Access Compliance Report

Public Rights-of-Way

(Curb Ramps)

Intersection ID: 46360	Main Street: GARDNER_LN	Cross Street: GARDNER_POND_CT	Location: SW
ADA ID: 81D61D8E987E	Ramp Type: PerpDiag	Initial Pass/Fail: Fail	Overall Compliance: No
Severity Score: 25			
Codes/Mitigation Info/Possible Solution		Field Measurements/Component Compliance

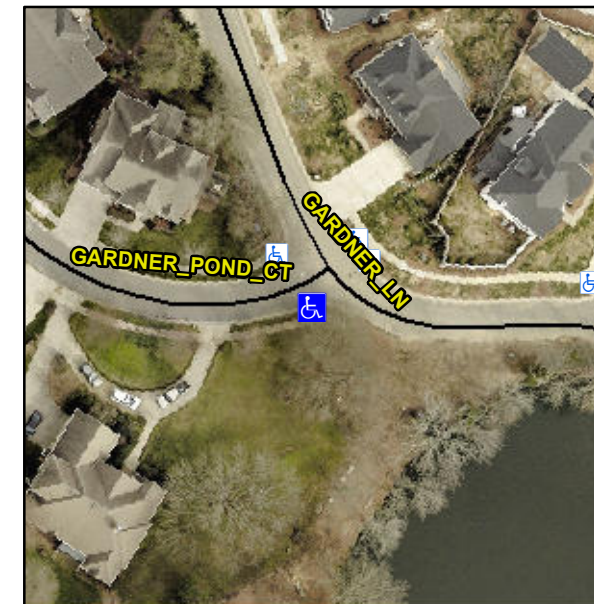
Not Found, R304.2.2, R304.5.3

Compliance	Description	Data	Compliance	Description	Data
N/A	Ramp Length (in)	48.0	No	Ramp Slope (%)	11.0
Yes	Ramp Width (in)	59.0	No	Ramp XSlope (%)	6.3
N/A	Flare Type LT	N/A	N/A	Flare Type RT	N/A
N/A	Flare Slope LT (%)	N/A	N/A	Flare Slope RT (%)	N/A
N/A	Flare Traversable LT?	N/A	N/A	Flare Traversable RT?	N/A
N/A	Landing Length (in)	N/A	N/A	DWS Provided?	N/A
N/A	Landing Width (in)	N/A	N/A	DWS Contrast?	N/A
N/A	Landing Slope (%)	N/A	N/A	DWS Length (in)	N/A
N/A	Landing X Slope (%)	N/A	N/A	DWS Full Width?	N/A
N/A	Landing Curb? (Y/N)	N/A	N/A	DWS Offset (in)	N/A
N/A	Shared Landing?	N/A			
N/A	Gutter Ponding?	N/A	N/A	Gutter Slope (%)	N/A
N/A	Gutter Lip Ht (in)	N/A	N/A	Gutter X Slope (%)	N/A
N/A	Painted X Walk1?	No	N/A	Painted X Walk2?	No
	X Walk 1 Direction	To NE		X Walk 2 Direction	To NW
N/A	X Walk 1 Width (in)	N/A	N/A	X Walk 2 Width (in)	N/A
	X Walk 1 Slope (%)	6.4		X Walk 2 Slope (%)	0.2
	X Walk 1 X Slope (%)	1.0		X Walk 2 X Slope (%)	6.4

Remove & Replace Curb Ramp With Two New Directional Ramps or Equivalent.
